Sadma Fashion Wear Ltd. (Extension 2)

Mouchak, Kaliakoir, Gazipur

1 October 2024

2. Observations

Observation 01: Mismatches in as-built drawings. (New Dyeing Building)

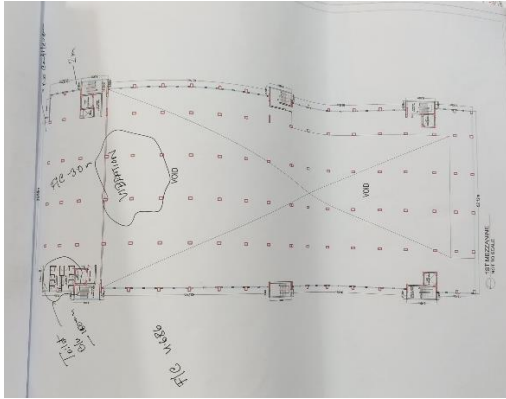
Description: The beam layout above the ground floor was found missing in the drawings. Also, architectural drawings were not fully matched on the 1st floor. Moreover, the toilet built-up is not shown in the drawings. The building engineer is required to prepare as-built drawings reflecting the on-site condition.

Item No	Observation	Action Plan	Timeline
1.	Mismatches in as-built drawings. (New Dyeing Building)	The building engineer is required to prepare as-built drawings reflecting the on-site condition.	within 6 weeks

Observation 02: Lack of information in the design report. (New Dyeing Building)

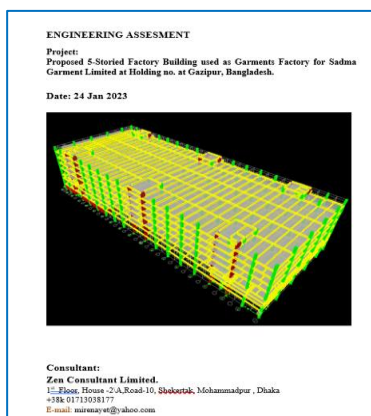
Description: A design report was available for the building in which wind load calculation, and concrete strength calculation according to BNBC 5.12 were not found. The structural design report needs to be revised as per 1.9.1 BNBC and submitted to RSC for further review.

2.	Lack of information in the design report. (New Dyeing Building)	The structural design report needs to be revised as per BNBC and submitted to RSC for further review.	within 6 weeks

3.	Lack of information in the design report. (New Dyeing Building)	Verify in situ concrete strength by taking concrete cores or existing cylinder test data that meets BNBC 5.12.	within 6 weeks

Observation 07: Lack of information in drawings. (New Utility building)

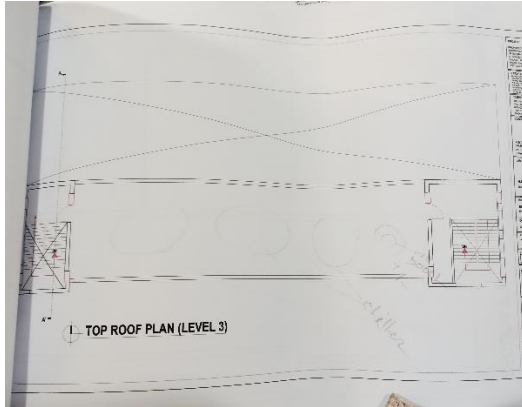
Description: The roof chiller and plastic water tank were not shown in the roof layout. The building engineer is required to prepare as-built drawings reflecting the on-site condition.

10.	Lack of information in drawings. (New Utility building)	The building engineer is required to prepare as-built drawings reflecting the on-site condition.	within 6 weeks

Observation 08: Absence of design documents and load plan (New Utility building).

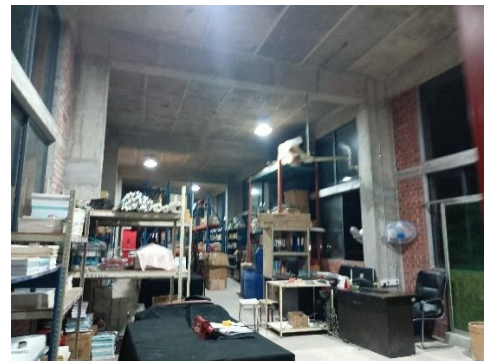
Description: As per BNBC, every building or structure designed shall have its design documents prepared following the provision of Section 1.9.1. The design document shall include a design report and a structural drawing. At the time of inspection, no design reports were available which are required to be prepared in compliance with section 1.9.1.1 and section 1.9.1.2 (part 6, BNBC).

11.	Absence of design documents and load plan (New Utility building).	Prepare design report for the structure as per 1.9.1 BNBC.	within 6 weeks
12.	Absence of design documents and load plan (New Utility building).	Implement the recommendations of the design report.	within 6 months

Observation 14: Lack of information in drawings. (Thermo Oil Heater Shed)

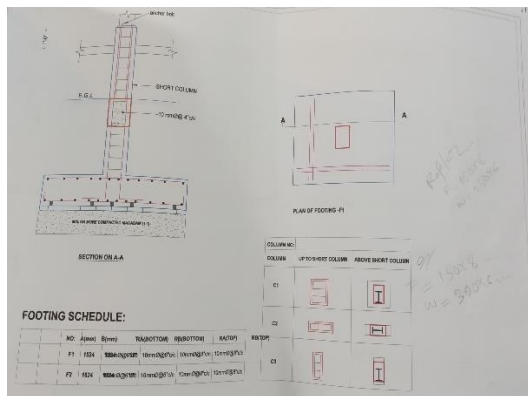
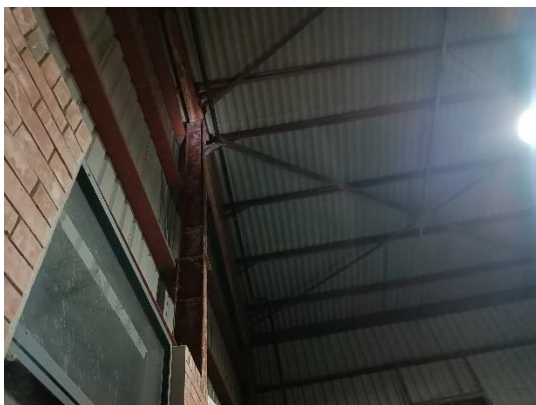
Description: Steel member size and connection details were not available on the provided drawings. The building engineer is required to prepare a full set of as-built drawings reflecting the on-site condition.

21.	Lack of information in drawings. (Thermo Oil Heater Shed)	The building engineer is required to prepare a full set of as-built drawings reflecting the on-site condition.	within 6 weeks

Observation 15: Absence of complete lateral load transfer media. (Thermo Oil Heater Shed).

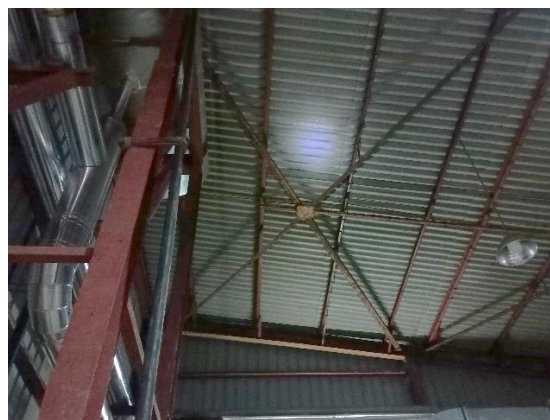
Description: Only roof bracing was available on the shed. Vertical bracing or compression strut was not found. The building engineer is required to check the connection & stability system (safety check) for the whole structure and suggest proper remediation accordingly following the Accord Building Standard.

22.	Absence of complete lateral load transfer media. (Thermo Oil Heater Shed)	The building engineer is required to check the connection & stability system (safety check) for the whole structure and suggest proper remediation accordingly following Accord Building Standards.	within 6 weeks

23.	Absence of complete lateral load transfer media. (Thermo Oil Heater Shed)	Implement the recommendations of the safety check report.	within 6 months
